Re: Turkey Point Units 3 and 4
Docket Nos. 50-250 and 50-251
Spent Fuel Pool Cask Area Rack Amendment
Clarification on RAI Response to NRC Questions 10a and 23

The purpose of this letter is to provide a revised response for RAI Question #10a and clarification to the response for RAI Question # 23. Attachment 1 provides the response to RAI Question # 10a, which supercedes in its entirety, the response provided in L-2003-213. Attachment 2 clarifies FPL's response to RAI Question # 23 by stating its commitment to Quality Control (QC) hold points in the procedure to verify correct cask area rack orientation. The original No Significant Hazards Determination remains valid with the information provided within.

Figure 1
Correct Unit 3 Rack Orientation

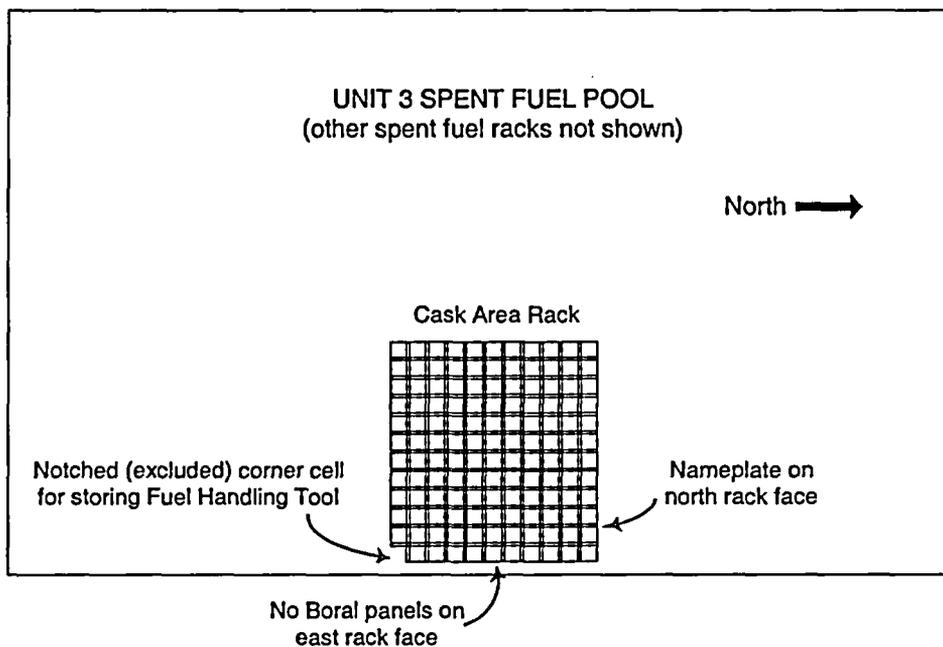
Clarification to the Response for RAI Question #23

See Figures 1 and 2 on the following page for the correct rack orientation in the Unit 3 and Unit 4 spent fuel pools, respectively.

Note that on both units, the rack face with no Boral panels faces the east pool wall; the notched (excluded) corner cell is adjacent to the east pool wall; and the rack nameplate is on the north rack face.

- With the cask area rack on the leveling pad located under the cask handling crane, verify that the rack nameplate is facing north (the nameplate is located near the top of the north rack face, near the northeast corner).
- Verify that the nameplate reads "Turkey Point Unit 3". ["Unit 4" in the Unit 4 procedure]
- Verify that the notch (excluded cell) in the rack corner is in the southeast corner of the Unit 3 rack. [northeast corner of the Unit 4 rack]

2. Following rack installation in the spent fuel pool cask area, a QC hold point will require verification of the following step:
 - Verify by visual observation that the notch (excluded cell) is adjacent to the east pool wall, in the southeast corner of the Unit 3 rack. [northeast corner of the Unit 4 rack]
